UNITED STATES PATENT AND TRADEMARK OFFICE

APPLICATION NO.	FILING DATE	FIRST NAMED INVENTOR	ATTORNEY DOCKET NO.	CONFIRMATION NO.
10/500,905	01/31/2005	Harry Richard Claringburn	P/62303	1397
156	7590	12/03/2008	EXAMINER	
KIRSCHSTEIN, OTTINGER, ISRAEL & SCHIFFMILLER, P.C. 425 FIFTH AVENUE 5TH FLOOR NEW YORK, NY 10016-2223			LIU, LI	
		ART UNIT	PAPER NUMBER	
		2613		
		MAIL DATE	DELIVERY MODE	
		12/03/2008	PAPER

Office Action Summary	Application No.	Applicant(s)	
	10/500,905	CLARINGBURN ET AL.	
	Examiner	Art Unit	
	LI LIU	2613

DETAILED ACTION

Figure O1

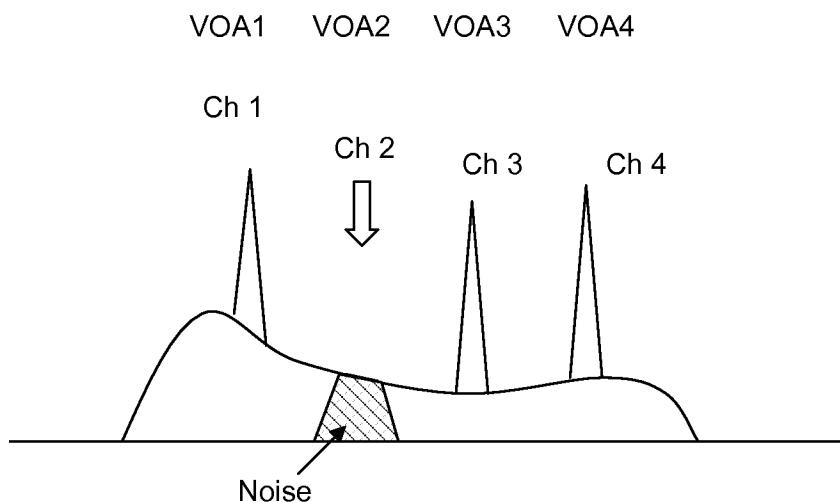
According to applicant disclosure, suppose there four signal paths (or channels) Ch1 – Ch4 in the system, and four variable optical attenuators (VOA1 – VOA4) are responsible for the four signal paths (or channels). While the channel Ch2 do not carry any signal to be added to the network, as shown in the position Ch2 in the following Figure O1, the signal path Ch2 has "no add content", and Ch2 in the signal path of the VOA2 has no any signal, or the channel Ch2 has no any wavelength signal. However, since the optical amplifier (e.g., 132 in Figure 2 or 140 in Figure 4 of applicant) is positioned before the VOA array, there is amplifier noise around the spectral position of Ch 2. That is, the "channel" (or signal path) Ch 2 carries amplifier noise, but does not have any signals to be added to the network. Then, the channel (Ch 2 in Figure O1), which has only noise, is blocked by the VOA2; and then the amplifier noise are filtered or blocked, and "improving or optimising the add channel OSNR" (page 3 line 14-15).

That is, the “blocking of channel” is to block noise in the signal path (or channel) since the “channel” has “no add content”, and no corresponding wavelength signal is present in the “channel” or signal path.
